- 12/19/18 CK - COMPLETED DESIGN FOR CLIENT & CITY REVIEW.
- 02/18/19 CK - UPDATED PER CITY REVIEW COMMENTS.

Uintah View Estates Improvement Plans

OGDEN CITY, WEBER COUNTY, UTAH
DECEMBER 2018

Details

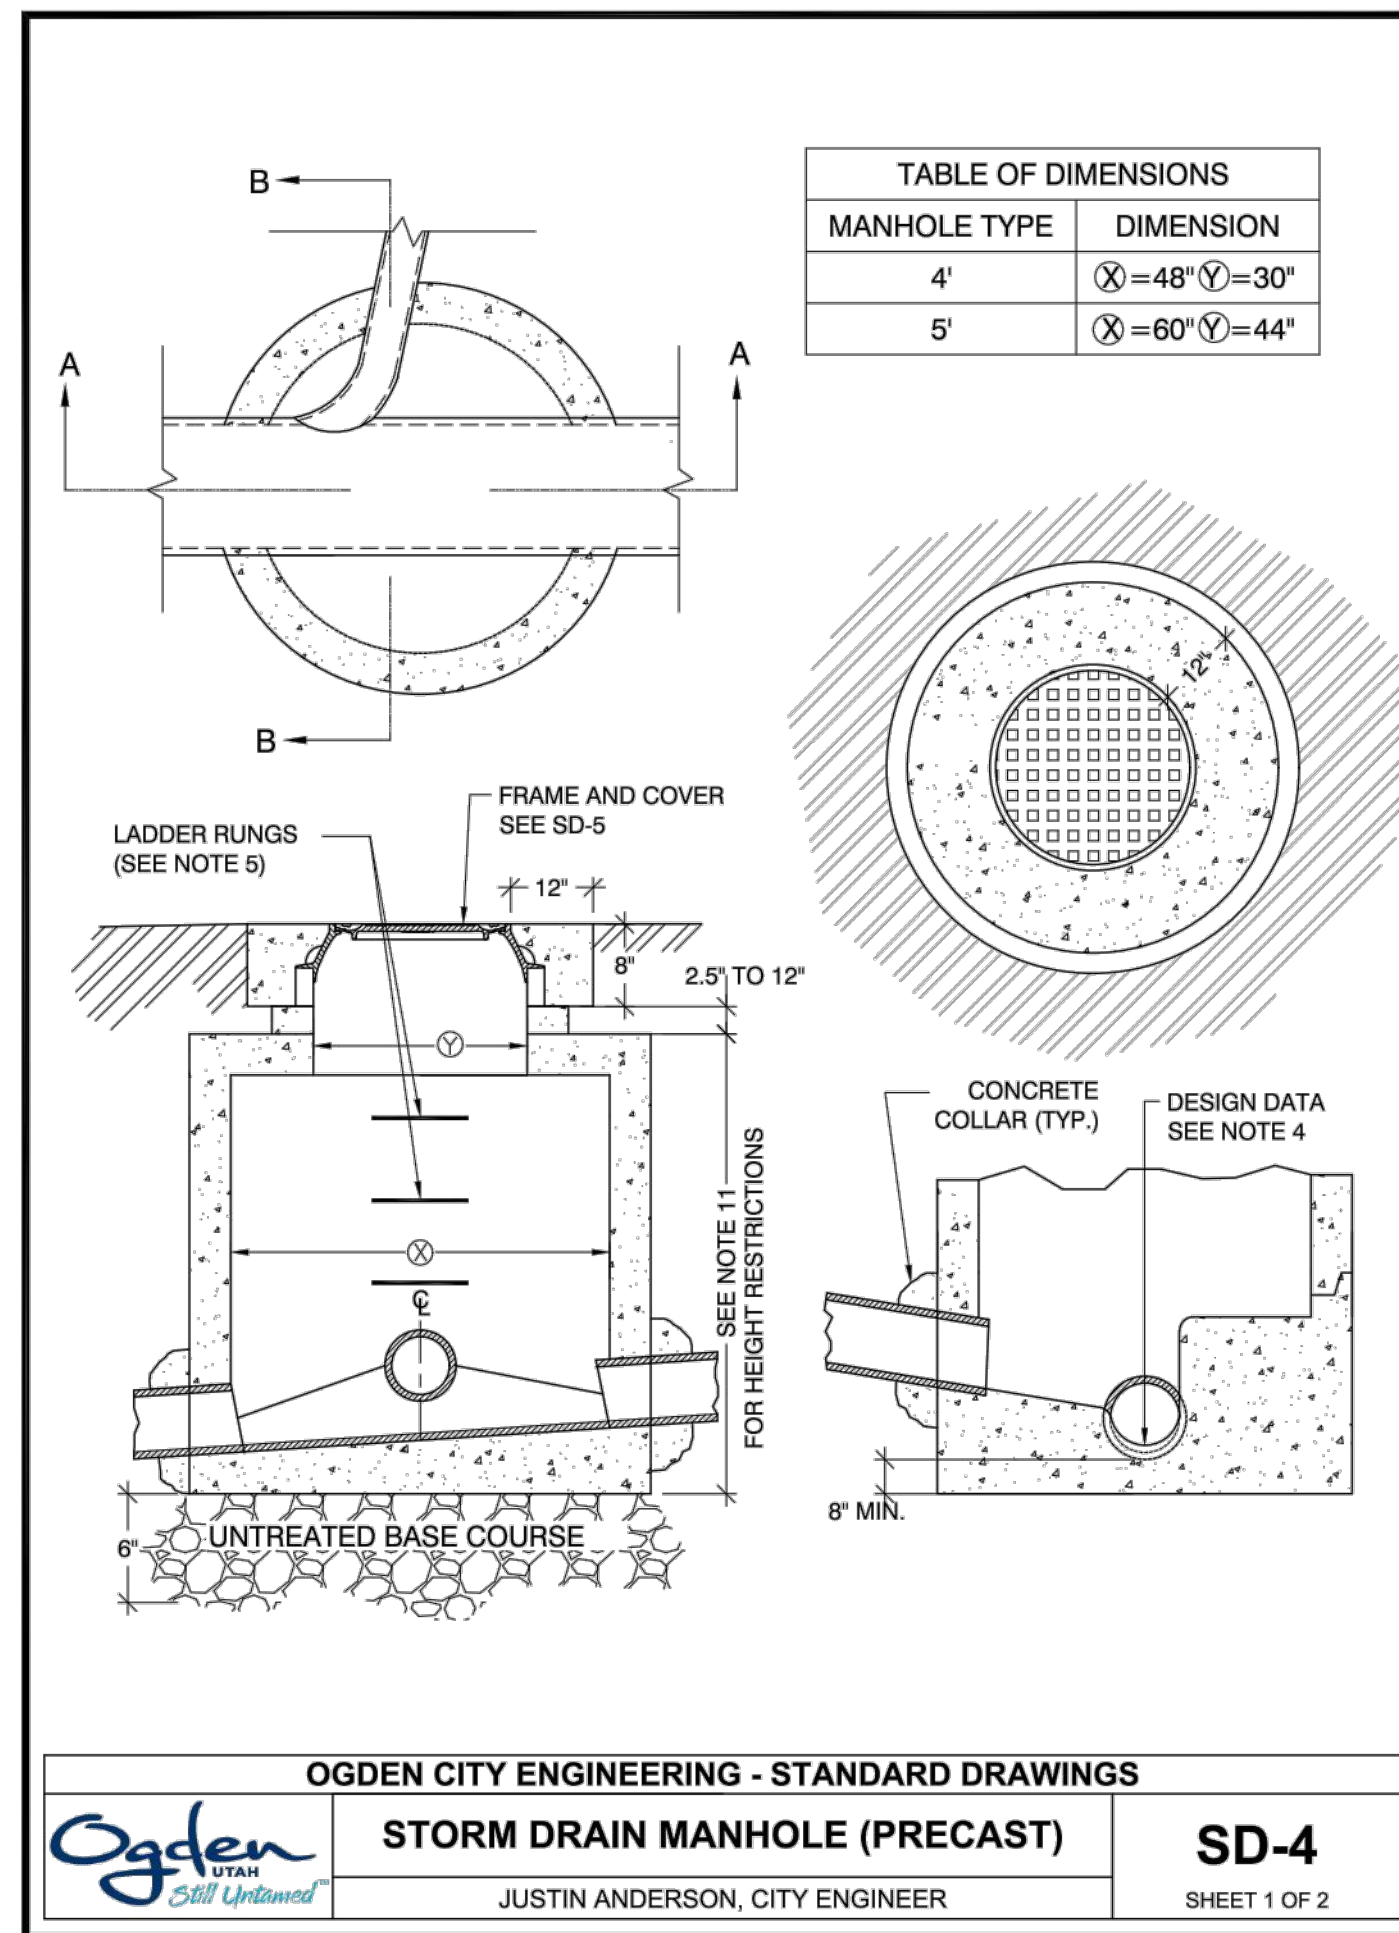
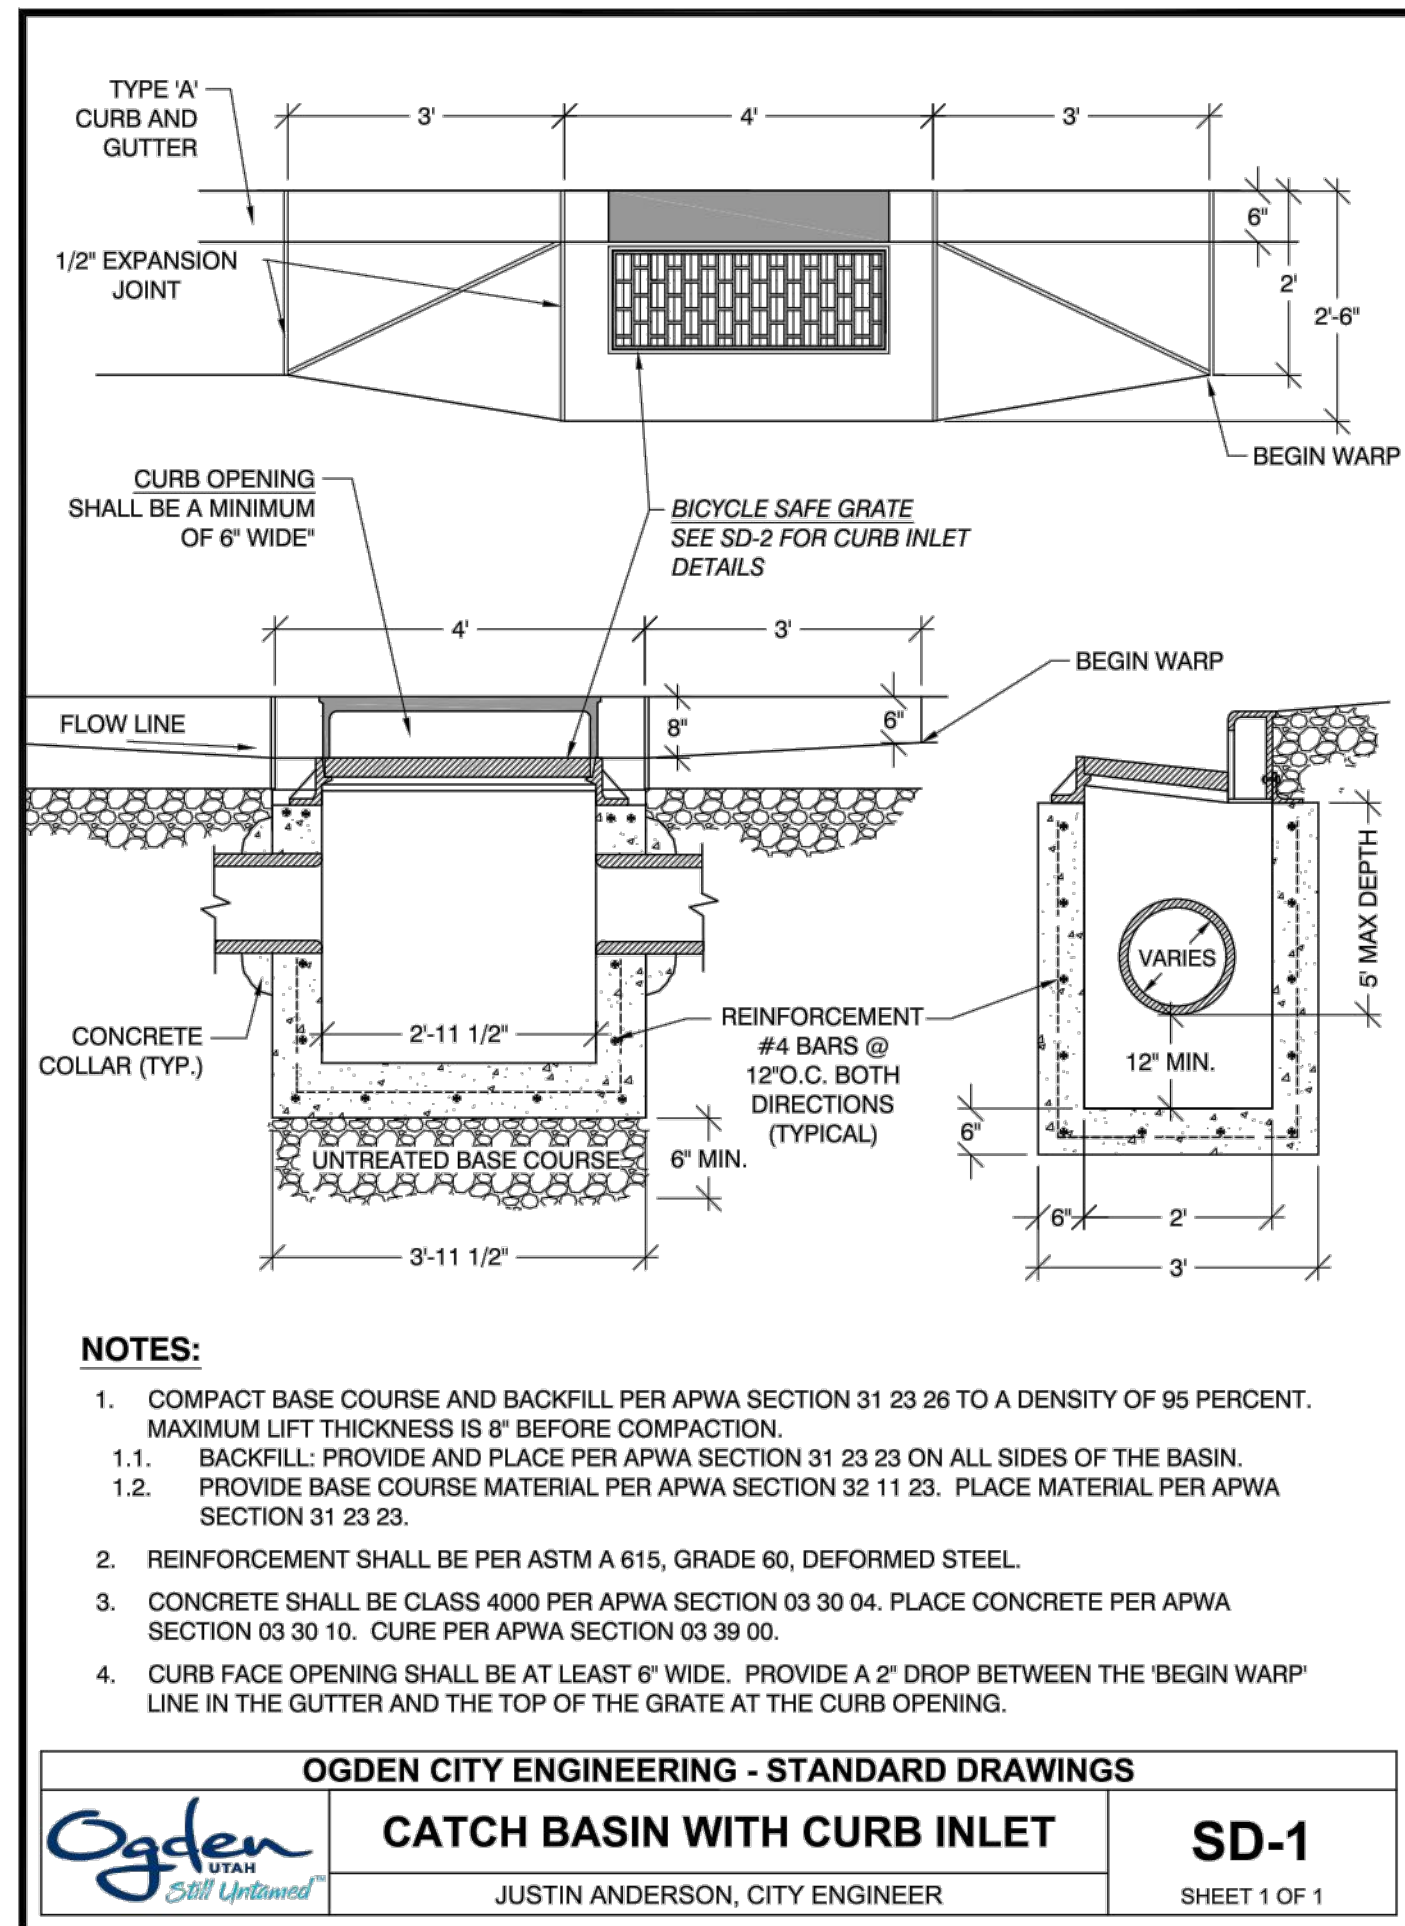
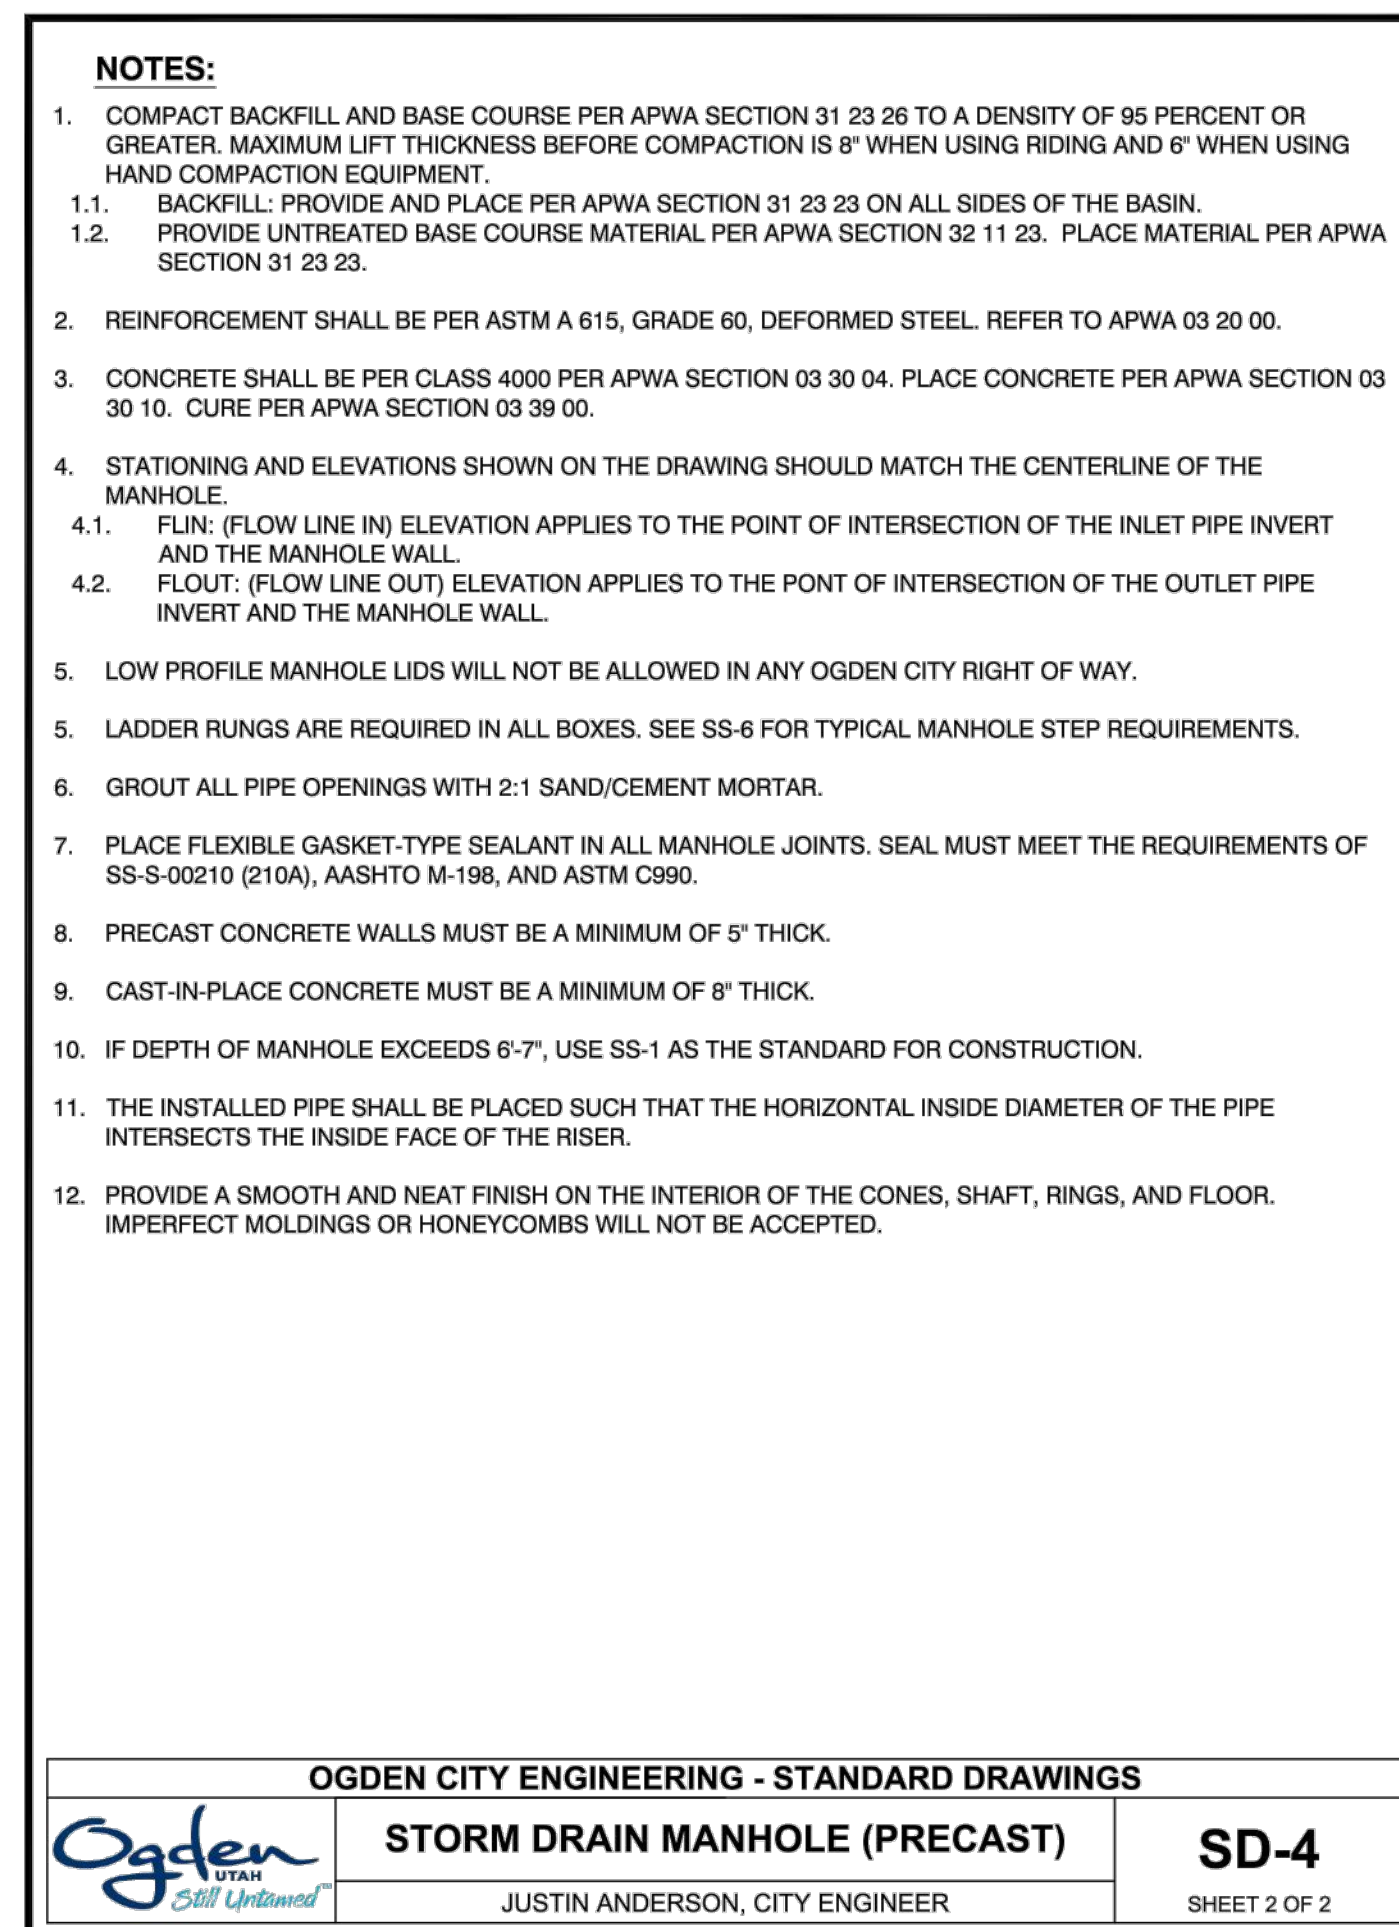
Use Weber County or APWA Specifications.
